Second Generation Active Louver Retrofit

Classification	Repair Bulletin	Section/Group	17 - Electrical	Country/Region	North America
Year	2012 - 2013	Model	Model S	Version	All

This Service Bulletin supersedes SB-14-17-004 R2, dated 8-Oct-14. Each content change is marked by a vertical line in the left margin. Discard the previous version and replace it with this one.

Figure 2 (2nd Generation active louver)

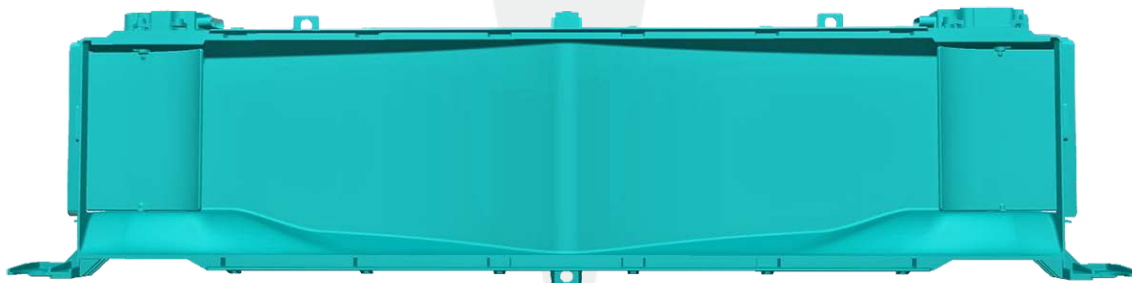
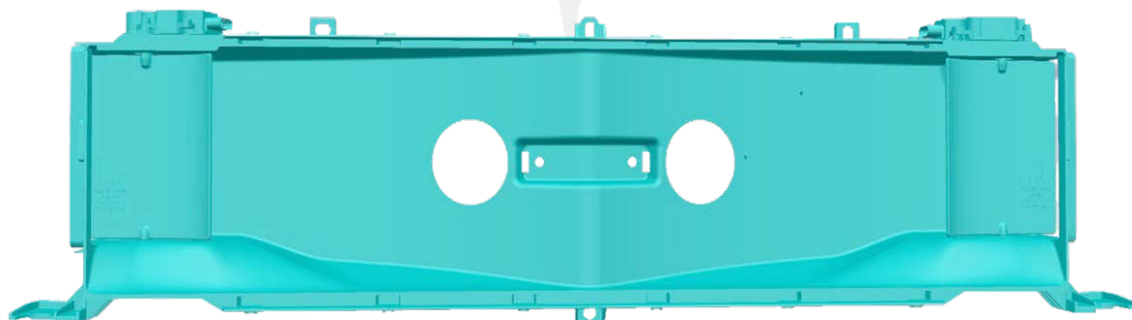
The 1st generation active louvers (Figure 1) are no longer available.

NOTE: The horns are mounted in the middle of the 2nd generation active louver. When retrofitting the 2nd generation active louver, it is also necessary to relocate the horns.

After a collision or another scenario where the active louver need to be replaced, retrofit the 2nd generation active louver assembly (Figure 2) and associated parts onto the vehicle. Refer to the Required Parts table.

Figure 3

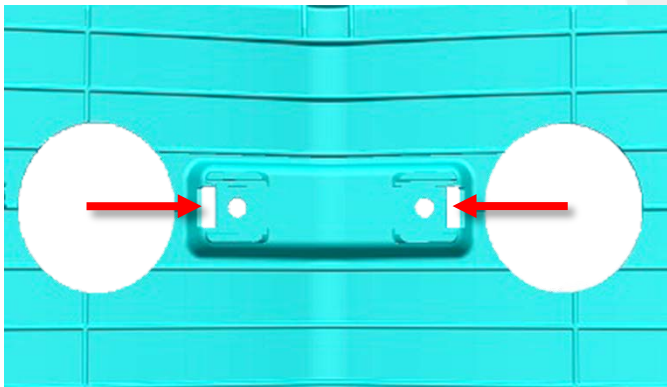
1. Remove and discard the active louver (refer to Service Manual procedure 18500602).
2. Set the new active louver on a soft, clean surface with the front side facing down.
3. Slide the clips inwards onto the bracket on the rear of the active louver (Figures 3 and 4).

Figure 7

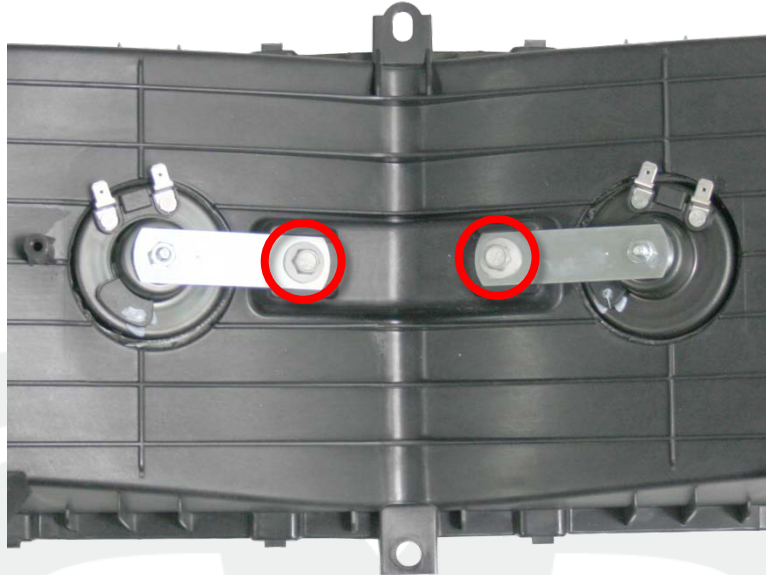
7. From the rear of the active louver, secure the brackets to the clips using the provided bolts (torque 5 Nm) (Figure 7).

Figure 8 (Outer circular cutouts highlighted)

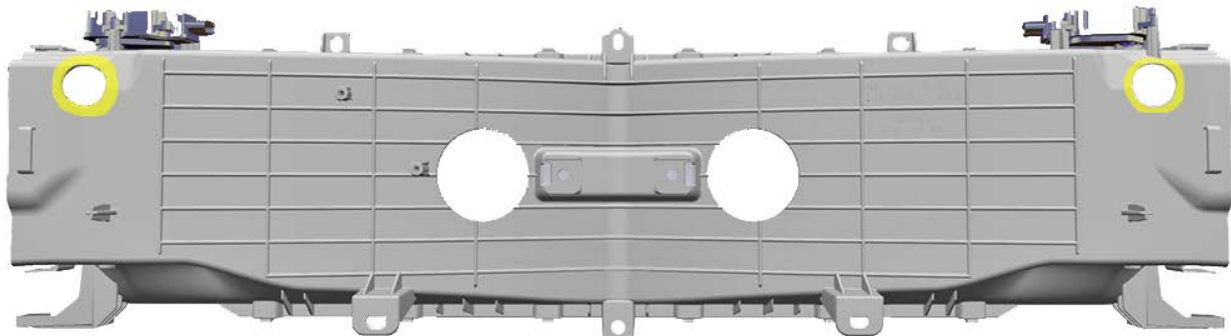
8. If the active louver is revision K or newer, remove the backing material from the small gaskets and adhere them to the rear of the active louver around the 2 outer circular cutouts (Figure 8). If the louver is revision H-J, discard the small gaskets.

NOTE: Ensure that the gaskets follow the contour of the circular cutouts.
